Metrohm Autolab Service Document # 009

Wrong transistor on control amplifier PCB sometimes triggers a failure in the i-interrupt

For PGSTAT128N and PGSTAT302N (8 Series)

Figure 3 – T7 is located at the bottom of the Control Amplifier PCB

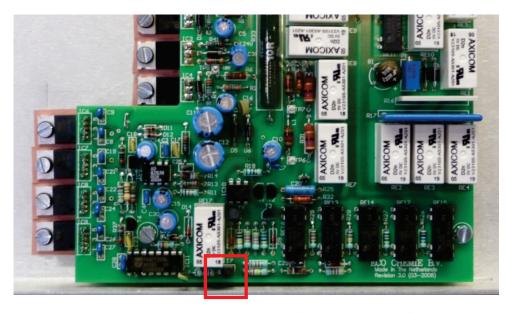
T7 on Control Amplifier PCB of PGSTAT128N (see Figure 3) T21 on Control Amplifier PCB of PGSTAT302N (see Figure 5)

PGSTAT128N Wrong transistor **T7**: BC547B, proper transistor **T7**: BC337-40 Wrong transistor **T21**: BC547B, proper transistor **T21**: BC337-40

The position of the transistor on the Control Amplifier PCB is shown in Figure 3.

If the wrong transistor is located on the PCB, simply remove the resistor by cutting the three terminal pins as high as possible (see Figure 4). Alternatively, if the clearance is not enough, break the housing of the transistor and remove the pins.

After cutting away the housing remove the remaining pins and remove the soldering material from the holes.

Cut the pins of the BC337 to length, insert and solder the three pins from the top.

Figure 5 – T21 is located at the bottom of the Control Amplifier PCB

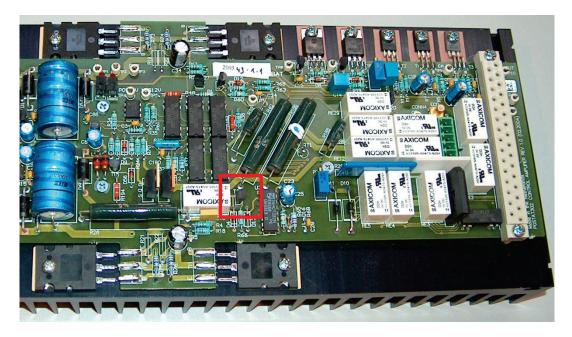
The position of the transistor on the Control Amplifier PCB is shown in Figure 5.

If the wrong transistor is located on the PCB, simply remove the resistor by cutting the three terminal pins as high as possible (see Figure 6). Alternatively, if the clearance is not enough, break the housing of the transistor and remove the pins.

After cutting away the housing remove the remaining pins and remove the soldering material from the holes.

Cut the pins of the BC337 to length, insert and solder the three pins from the top.
